From: City of Ann Arbor Transportation Commission
Sent: Friday, October 14, 2022 12:25 PM
To: Cespedes, Christopher
Subject: FW: All Ages And Abilities Bike Network

From: Adam Goodman <XXXXXXXXXX>
Sent: Saturday, September 24, 2022 9:32 PM
To: City of Ann Arbor Transportation Commission <XXXXXXXXXX >; Engineering XXXXXXXXXXX
Cc: Kleinman, Molly <XXXXXXXXXX> ; Briggs, Erica XXXXXXXXXXX
Subject: All Ages And Abilities Bike Network

Proposed Full-Width Section Separated Bike Lane

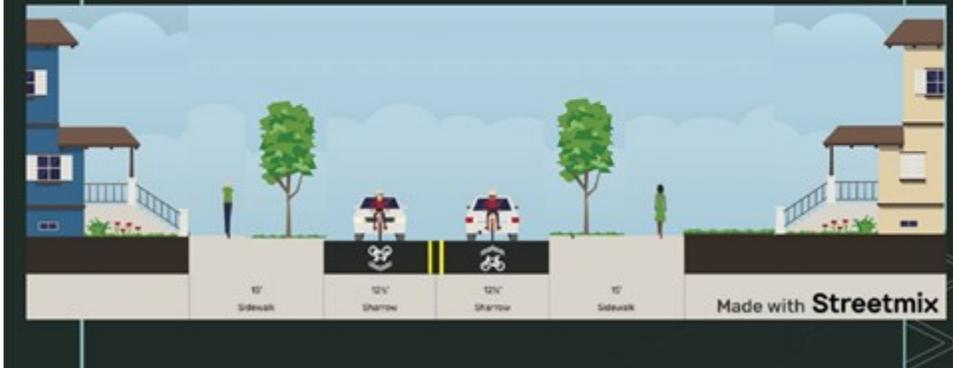
Third: the design presented for a "separated bike lane" makes zero sense:

The idea of a separated bike lane (separated by delineators or a curb) is that *cars should not cross into that space*. Ideally, delineators should be placed closely enough together that cars cannot cross without hitting them. But, in this scenario, putting street parking behind the delineators renders them utterly pointless. The design should be the other way around.
